RE: Planning Application - No. 48 Templeroan Way, Dublin 16

Please find attached a planning application relating to the above site. The application seeks permission for 2 no. 2 storey semi-detached two bedroom dwellings with all associated site, landscaping, boundary and ancillary works

This application has been amended to take account of the reasons for refusal in the previous planning decision. These reasons and our response are outlined below -

Image 03 – Aerial View showing existing side elevation with no windows to habitable rooms

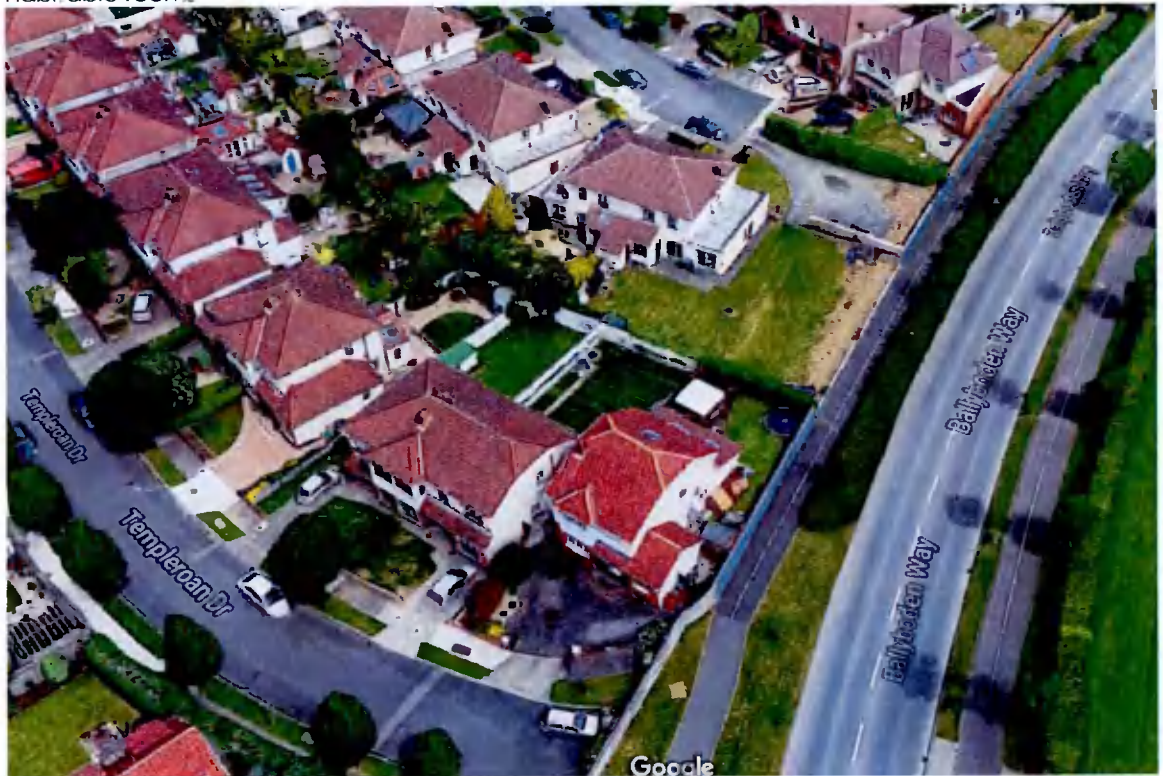
1. **The proposed new dwellings, by reason of the excessive height and depth of the structure proposed directly on a shared site boundary and proximity to a neighbouring residential property including habitable room windows and their private amenity space, would result in a significant and material loss of light, overshadowing and unacceptable sense of enclosure. In addition to this,**

the proposal would result in harmful overlooking between directly facing habitable room windows, to the properties to the south-west of the application site. The proposed development is considered to be over development of the site. Thus, the proposed development would seriously injure the amenity of property in the vicinity and would be contrary to the zoning objective for the area which seeks 'to protect/and or improve residential amenity' and would therefore be contrary to the South Dublin County Council Development Plan 2016 - 2022 and the proper planning and sustainable development of the area.

- The design has been reduced in size at first floor with the removal of the proposed home office. This has the effect of reducing the depth of the first floor plan and ensuring a separation distance in excess of 22M between first floor windows (22.3M)
- The proposed dwellings are not directly on a shared site boundary. There is an access passageway alongside both dwellings which means that in conjunction with the set back on the existing house there is no significant impact on the existing property
- There are no windows to any habitable room windows on the façade / side elevation of the existing house which faces onto the proposed site. Therefore there can be no impact on any habitable rooms

Image 06 - Google Map Extract

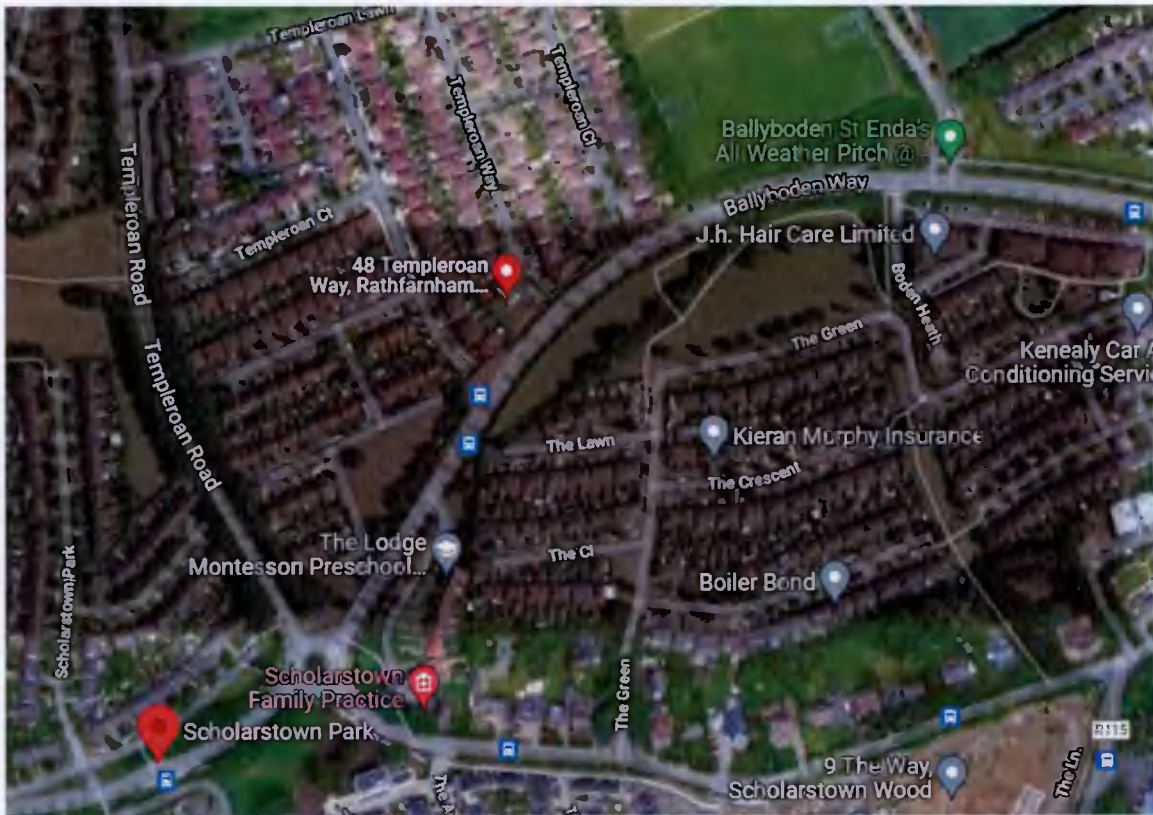
2. **Insufficient space would be provided within the application site for the parking of four cars to meet parking standards in a safe manner and in particular would prevent car occupants from safely accessing and egressing parked vehicles due to the restricted nature of the site which in turn could lead to traffic displacement in the surrounding area. In addition to this the proposed entrance would impede access to the existing vehicular access of the neighbouring property and vice versa. These factors would lead to a traffic hazard and unsafe conditions for pedestrians and therefore the proposed development would be contrary to the proper planning and sustainable development of the area.**

- Flexibility on parking provisions can be considered for infill housing
- The proposed dwellings are close to frequent public transport with bus stops and routes within 500M on Ballyboden Way (Dublin Bus Stop 7743 – Route 15B & 175)

Image 07 – Massing Model Study

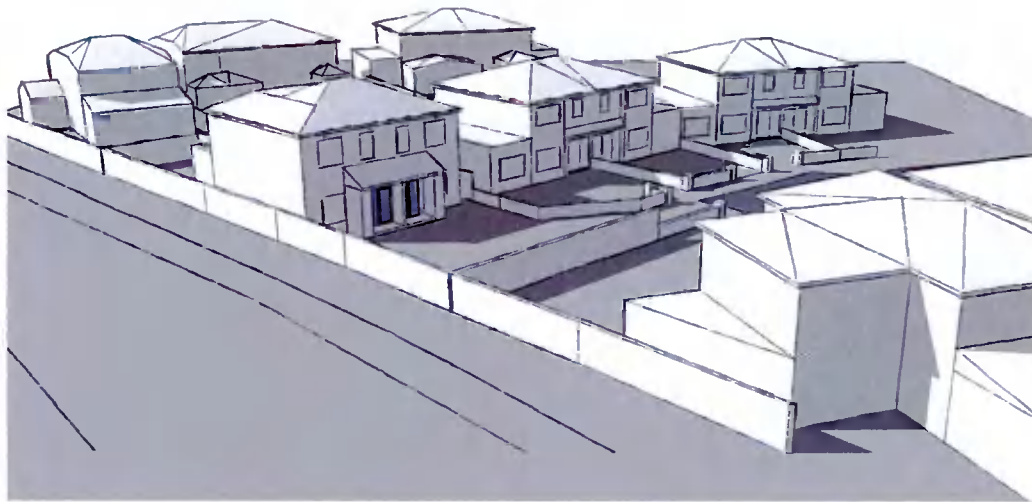
visually the current proposal would be an improvement on the refused scheme. However, there are other significant concerns with the proposal that remain that the applicant has failed to address and therefore limited weight can be given to the new design.

We are somewhat unsure as to what these comments refer given that the proposed design has been designed to match as closely as possible to the existing streetscape and design type of the existing dwellings. Efforts to discuss the comments with the planner have been unsuccessful but our client is open to conditions with any grant of permission which would seek to amend the design.

We have included images below of a 3D model of the proposed houses and context. These show that they sit comfortably within the existing site context – particularly given the existing infill developments on similar plots to the front and rear
